August 23, 2023

RE: Supplemental Memorandum  
Related to Letter of Intent for Club Car Wash  
3909 and 3913 Lien Road

3913 LIEN ROAD SITE IMPROVEMENT PLAN  
FOR CLUB CAR WASH  
CITY OF MADISON  
DANE COUNTY, WISCONSIN

SITE PLAN

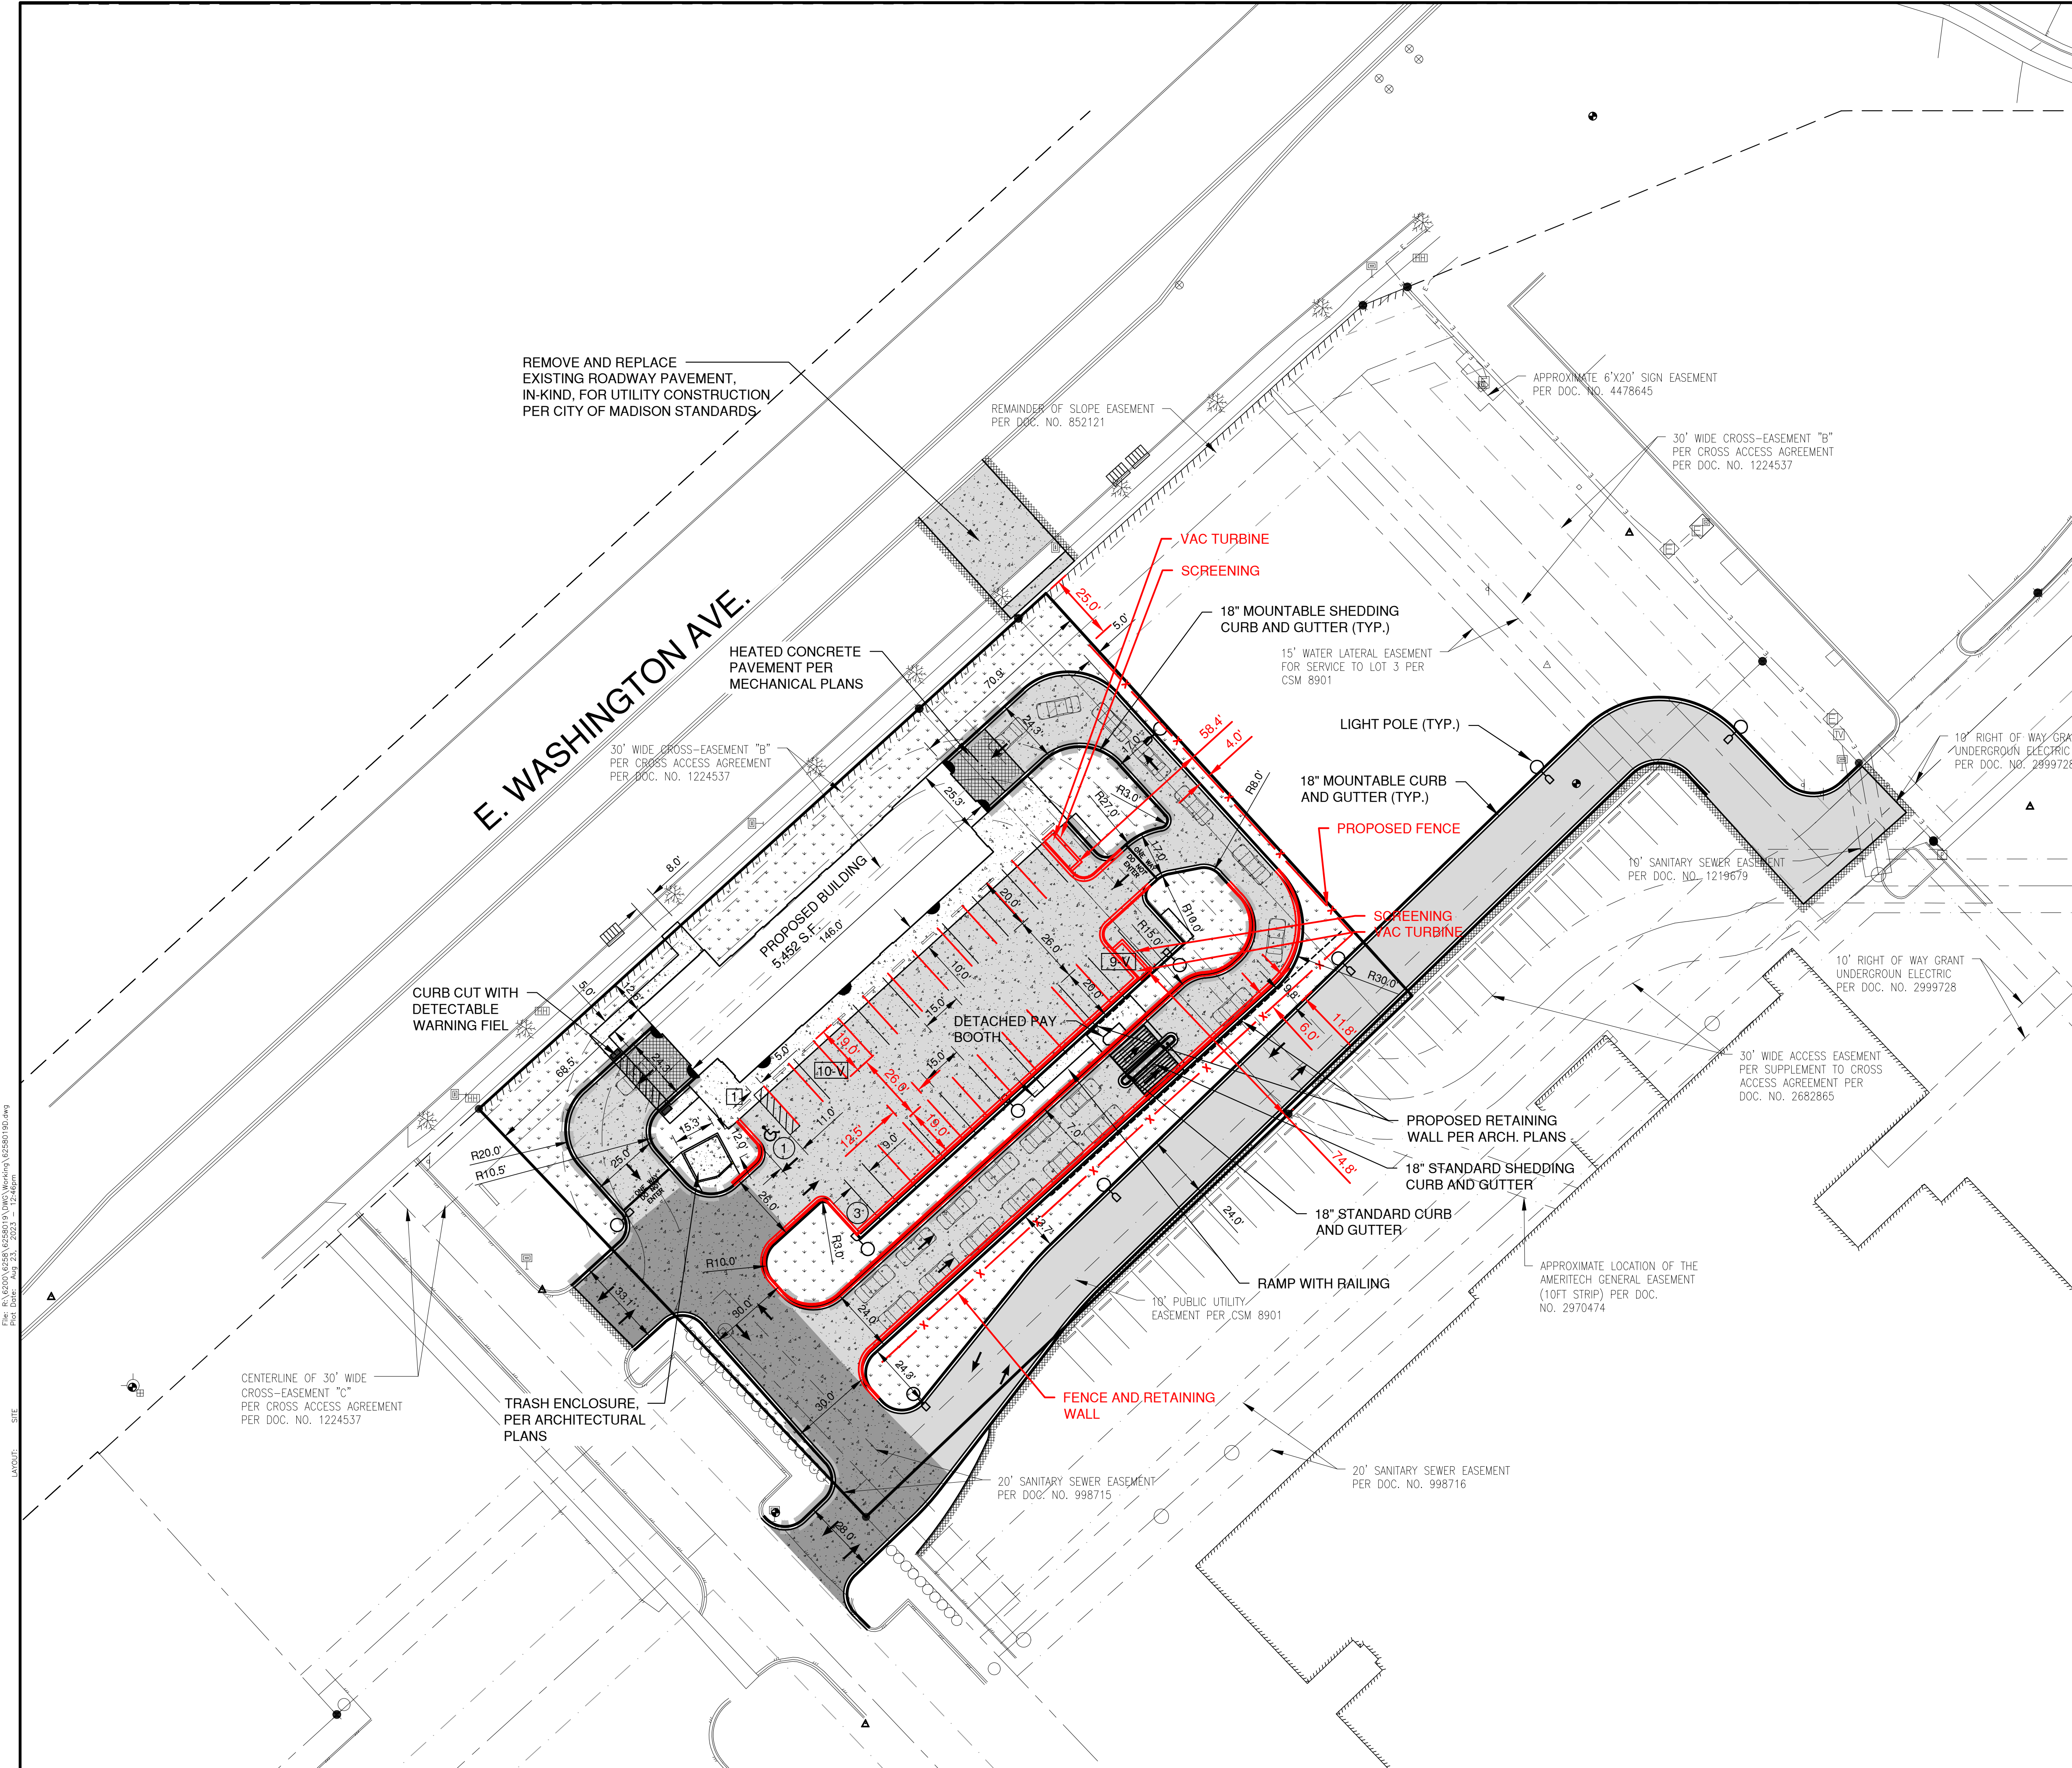
- Applicant proposes reducing the geometric configuration of the parking area to reduce vacuum stall sizes, and thus potentially reducing the amount of impervious surface on the site.

- The attached site plan illustrates reduction of the vacuum stall size to 12.5'x19' (down from 15'x20'). This reduces pavement by roughly 400 square feet and allows for an increase of 2 feet in the buffer space on the south boundary so that additional landscape can be added. This pulls the vacuums further away from the southern property line and also allows for additional landscape for sound mitigation on the south property boundary.

- Applicant will add a solid fence on the eastern and southern property lines that will further mitigate sound generated from the vacuum turbines. In addition, on the outside face of the southern fence (facing towards the southern properties) Applicant will include additional landscape beyond that shown in the submitted landscape plan which will include trees and shrubs to assist with additional sound mitigation.

## FIRST FLOOR NORTH ELEVATION

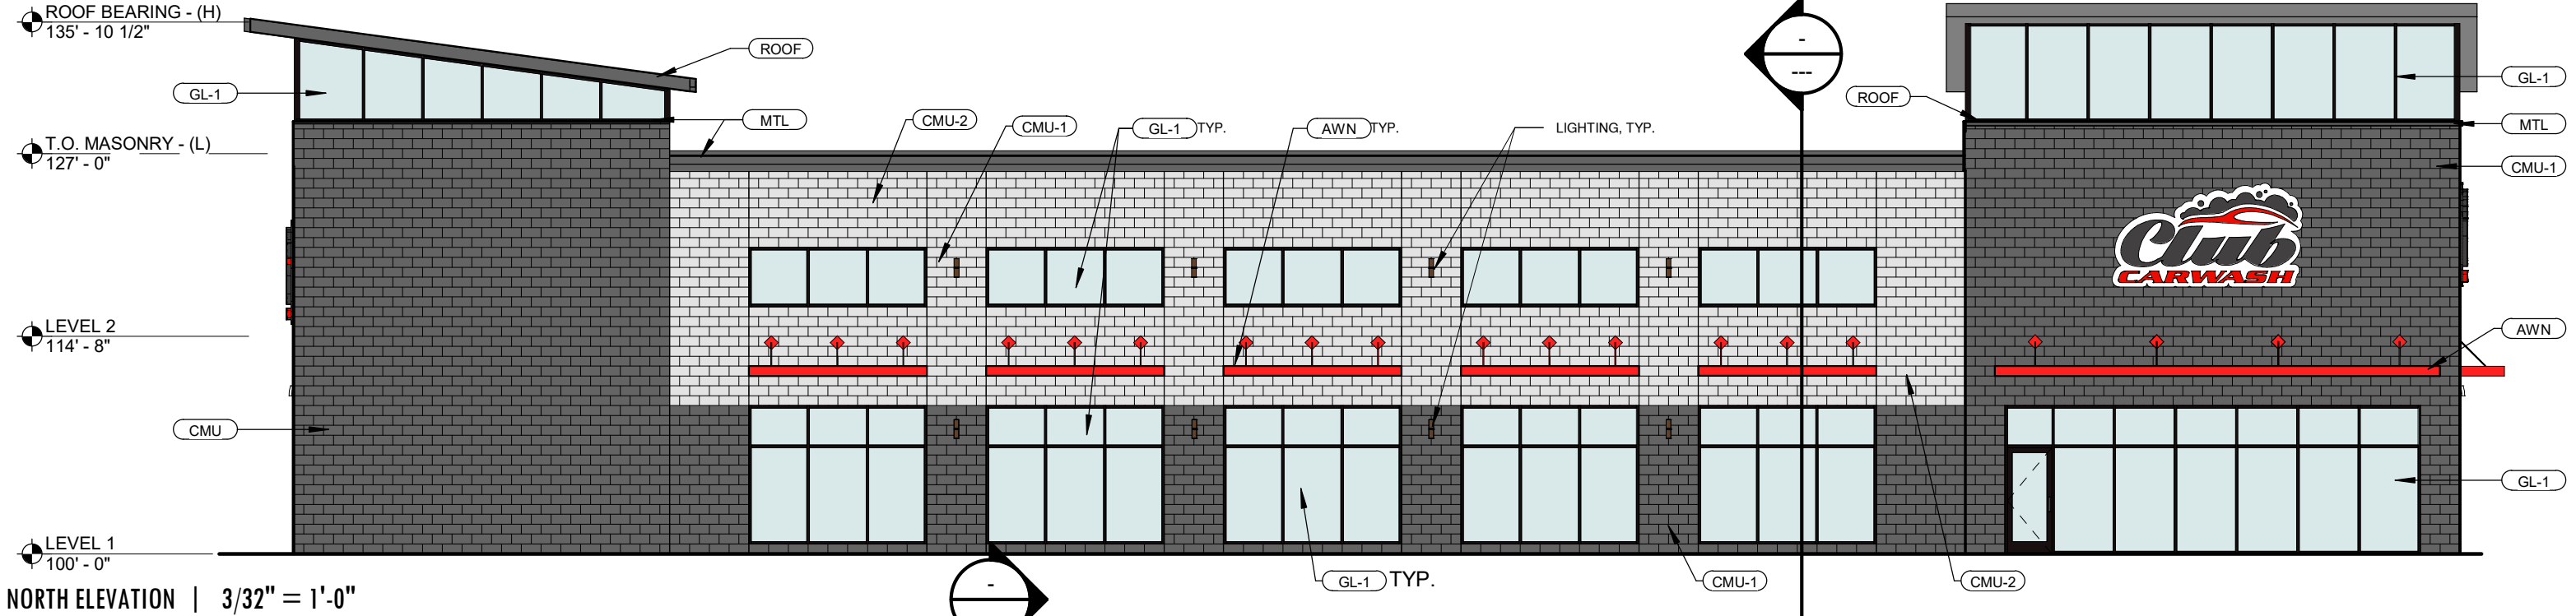
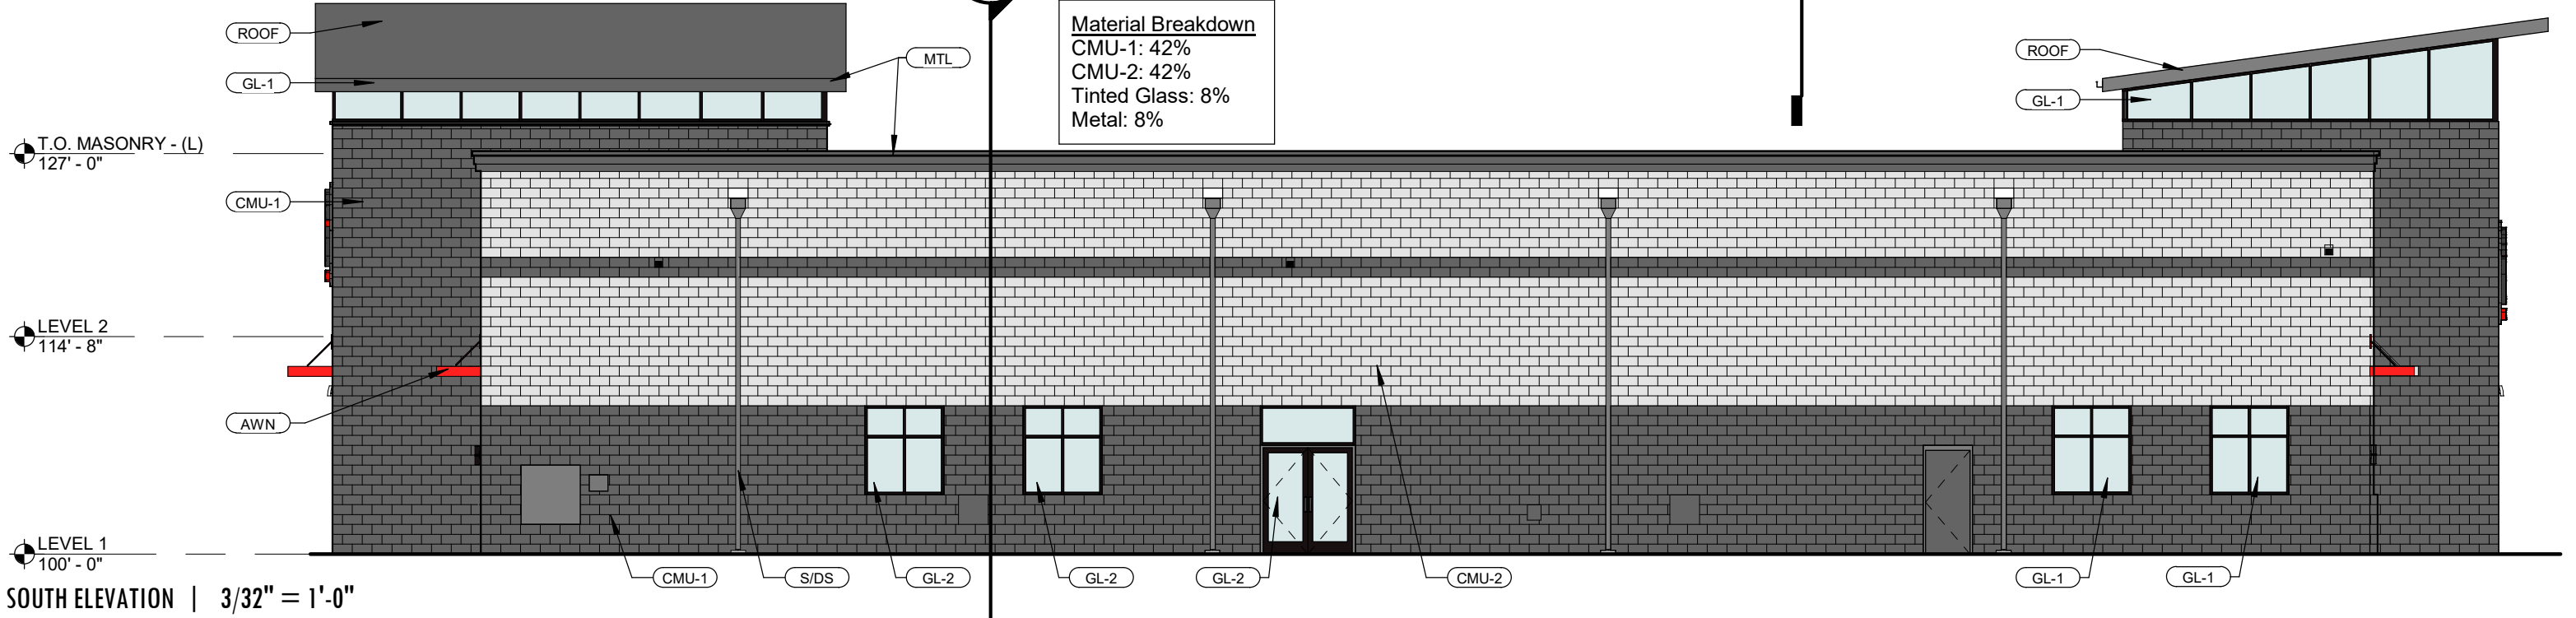
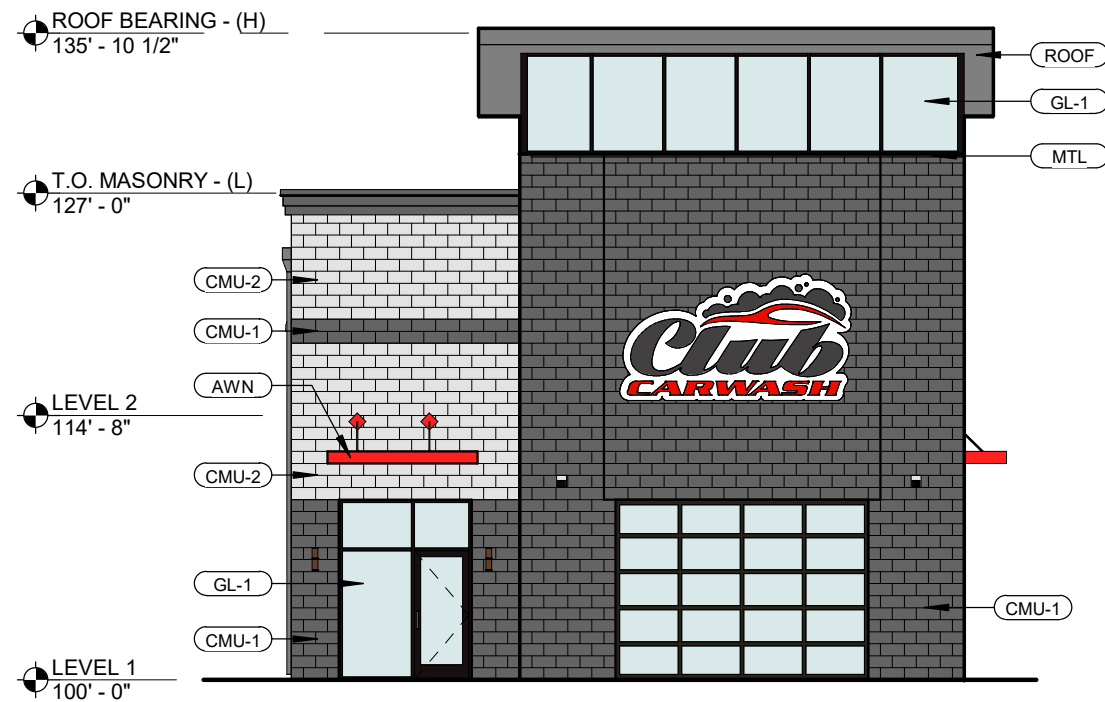
B. With respect to the building design, Applicant received comments from the Urban Design Commission as well as from City staff, including comments on building materials as well as the placement of windows on the second floor of the building and the slope direction of the tower. Attached hereto in response to those comments please find updated supplemental elevations and an updated rendering reflecting changes as follows:

1. Raising the height of the second story windows.
2. Replacement of CMU with burnished block and change in location of burnished block on the building.
3. Replacement of EIFS with burnished block.
4. Rotation of the slope direction of the tower.
